Powerhouse Precinct Parramatta

Powerhouse SSSA report – Security
CPTED Assessment - Addendum

PHM-ARP-REP-SC-0005

Issue 05 | 8 October 2020

Figure 3 Undercroft access points (River Level)

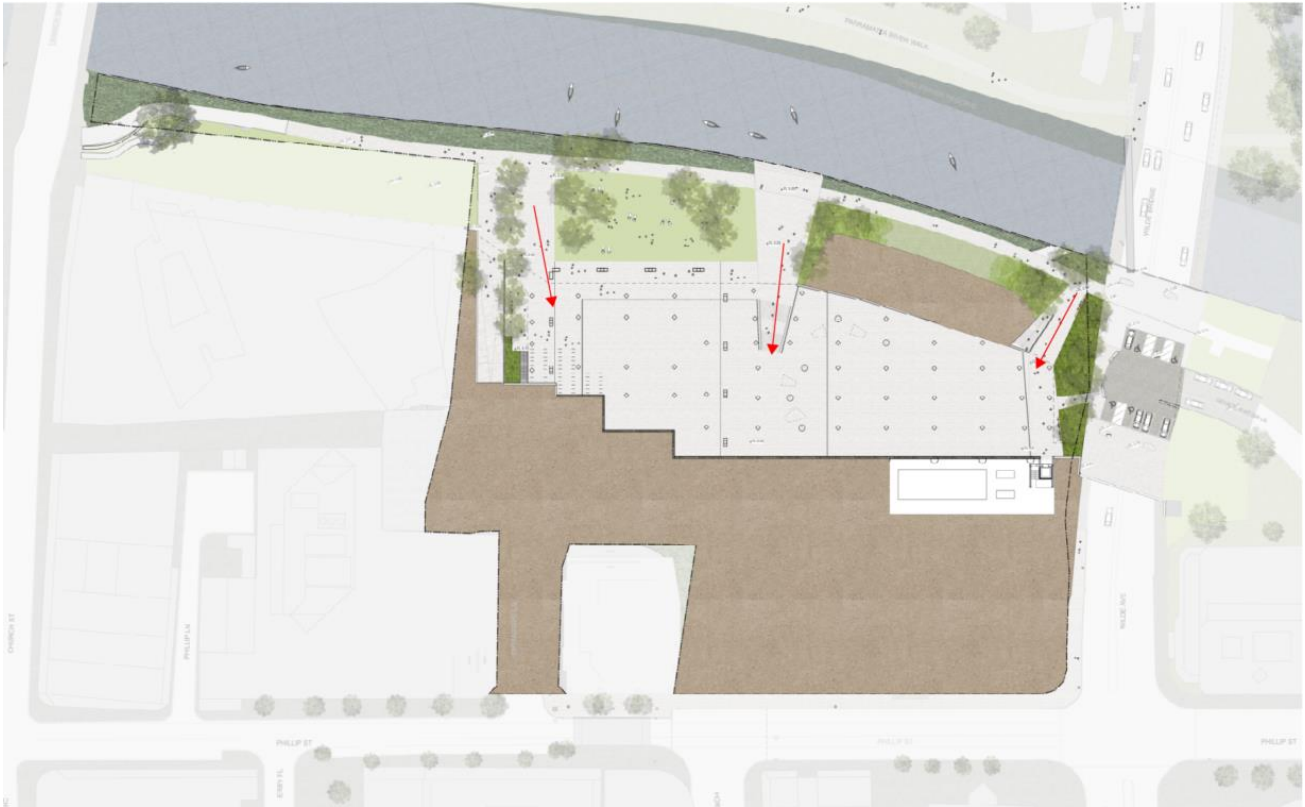
The undercroft is shown on the plan with pedestrian access from multiple points. Structural elements of an undercroft mean it is a large open (but undercover) space with reduced sightlines from structural columns, similar to underground parking structures. The undercroft is accessible from three ends beneath the Podium (see Figure 3), with visual surveillance from the building or lawns above obscured by the Podium. This limits passive surveillance specifically to other users of the undercroft during operational hours and may present opportunities for criminal or antisocial behaviour with this reduced likelihood of detection.

However, the area will only be accessible to the public for managed events by Powerhouse. At all other times the area will be closed to the public through the use of screens.

The screens will only be open for managed events where staff will be in attendance. In addition, 24 hour on-site security and CCTV will assist with management of the space. The only other time that the undercroft screens will be opened is in the event of a flood, where there will be no people allowed within the space.

Figure 4 Architectural Plans showing the undercroft location, with adjacent bicycle storage facility

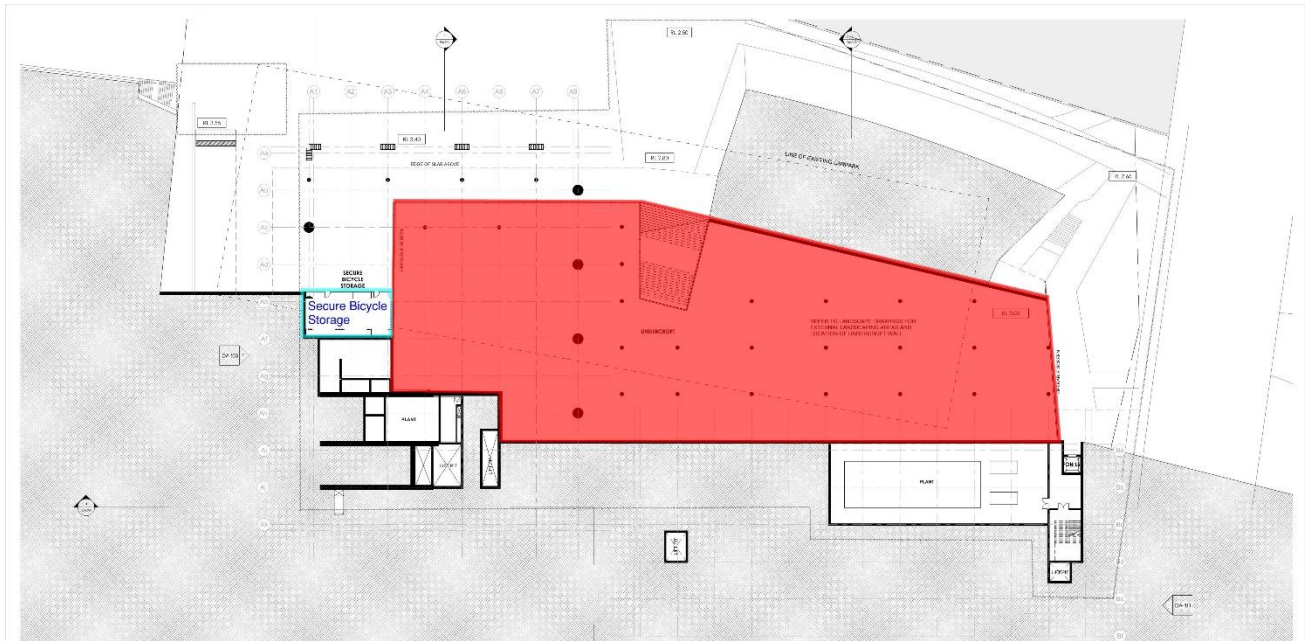
Crime threat scenarios for the undercroft may include: crimes against the person such as assault and theft, property crimes including break and enter, graffiti/vandalism and motor vehicle or bicycle theft. It is also noted that adjacent to this undercroft is a secure bicycle facility which may attract criminal activity such as theft or property damage. This facility is shown in Figure 4.

The following CPTED strategies are proposed for the undercroft:

- Comprehensive CCTV coverage;
- Adequate lighting
- Operational plans for presence during managed events with security patrols and CCTV monitoring by 24-hour onsite security; and
- Clear wayfinding signage that indicates pathways for patrons.

Figure 6 Powerhouse Museum Precinct Seating Areas

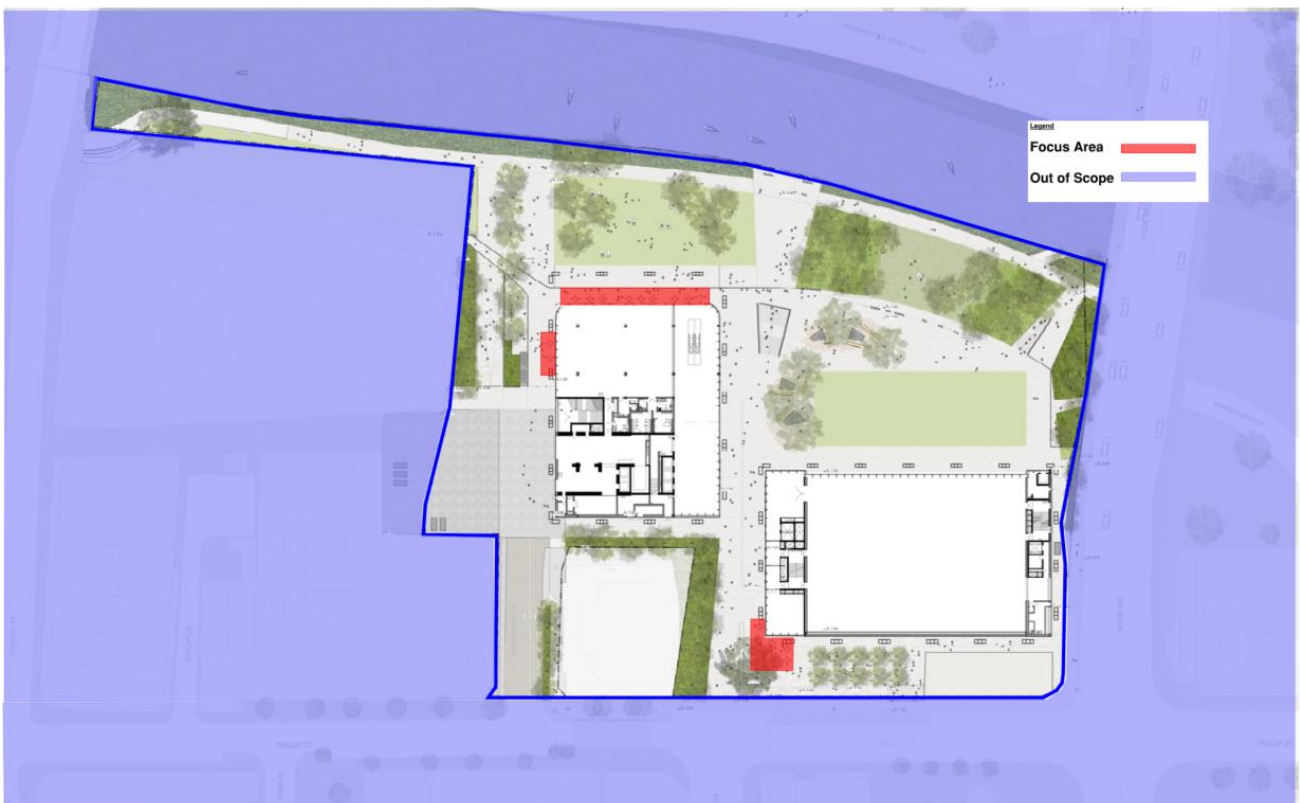
The amended landscape design has two additional seating areas compared to the design lodged with the EIS. Despite these additional seating areas, the impacts of CPTED remain consistent.

The presence of seating is anticipated to encourage patronage in this area during operational hours – facilitating natural surveillance. It should be noted that, as with other locations, this space may present opportunities for a range of crime threats out of hours, including: crimes against the person – i.e. assault, steal from person and intimidation, stalking and harassment. It is noted that crimes against the property, such as vandalism of seating and tables is also a potential threat scenario identified for seating locations. CPTED strategies proposed for seating areas include:

- Implementing regular maintenance schemes in line with the site-wide recommendations to repair/restore furniture that is damaged.
- Designing lighting to enable pedestrians seated in the area to identify potential security hazards around them;
- Vandal resistant materials and finishes should be considered for furniture. Additionally, removable furniture can be considered for usage while complying with the proposed strategies.
- Implement signage/ changes to pavement material/ texture to direct patrons to safe pathways.

Figure 8 Powerhouse Museum Precinct Coach Stop

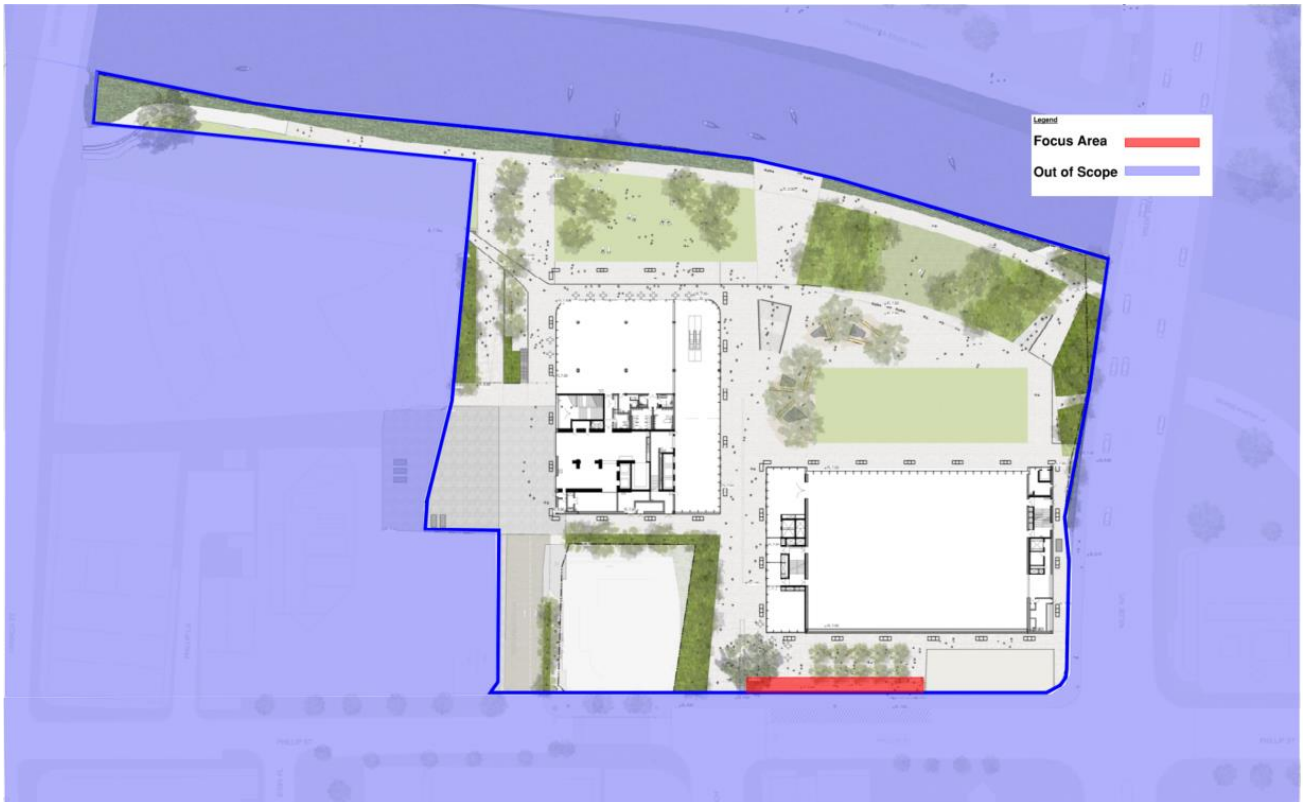
A coach stop area is shown on the current plan that has been relocated to Phillip Street rather than an indented bay as per the design lodged with the EIS (see Figure 8). Despite the design change, the recommendations provided for CPTED remain consistent.

While the bus stops are expected to encourage patronage of the location – and it is located on a main road – late-night usage may present opportunities for isolated patrons to be targeted by threat actors. However, it is noted that this stop is not intended for public use, but instead by coaches for school excursions, tour groups and other such groups. As such, it is not expected that users of this location will be loitering in this space outside of Powerhouse Parramatta’s operating hours.

While large groups at any given time are likely to deter potential offenders, there still exists a number of potential crime threat scenarios. These include assault, theft from the person and intimidation, stalking and harassment. In addition, crimes against property are a possibility, including vandalism of the bus stop and associated assets. The following CPTED strategies are provided for the coach stop:

- Minimise potential hiding opportunities by facilitating clear passive surveillance of the bus stop from the footpath and roadway. Consider impact on visibility of assets such as the terraces, rubbish bins, bus shelters and landscaping;
- Where possible, sightlines are to be maximised from the nearby terraces to enable visibility of surrounding areas, e.g. removing vegetation that may obstruct sightlines;
- Implement lighting and maintenance strategies consistent with the site wide guidelines, particularly in the surrounding space involving the terraces;
- Vandal resistant materials and finishes should be considered for any bus stop assets (e.g. shelters, signage) that are proposed.
